**E4447A-01**

**S E R V I C E N O T E**

PSA Series Spectrum Analyzers with Options 233 and 110,  
and Option Driver Assembly p/n E4440-60253

**Tuned RF Level Range 2 to Range 3 Switching Time Improvement**

**Figure 1. Option Driver assembly location.**

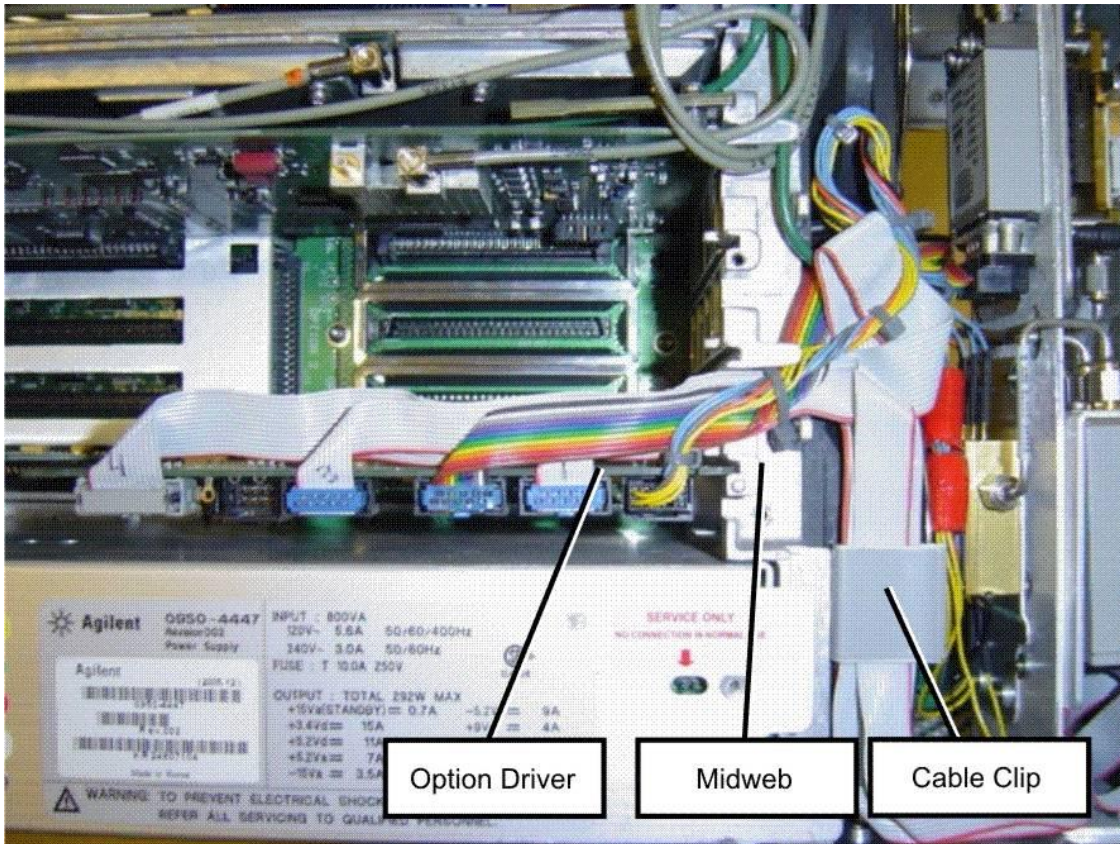
1. Remove the analyzer’s outer case and top brace. See the PSA Service Guide for the procedure to remove and replace these covers.
2. With the instrument powered down, locate the Option Driver assembly shown in **Figure 1**. Notice how the ribbon cables connected to the board assembly are routed near the instrument fans. This

- Without removing any cables from the option driver, carefully unseat the board assembly from the motherboard. You will need to remove the ribbon cables from the cable clip and possibly remove the cable tie near the mid web. Pull the board out of the instrument only far enough to expose connector J2.
- See Figure 2. Locate J2 near the middle of the board. Connect the ribbon cable from the Parallel Cable's pod to the JTAG connector, J2, on the A38 option Driver Assembly being careful to align the keying tab on the cable with the J2 header slot.
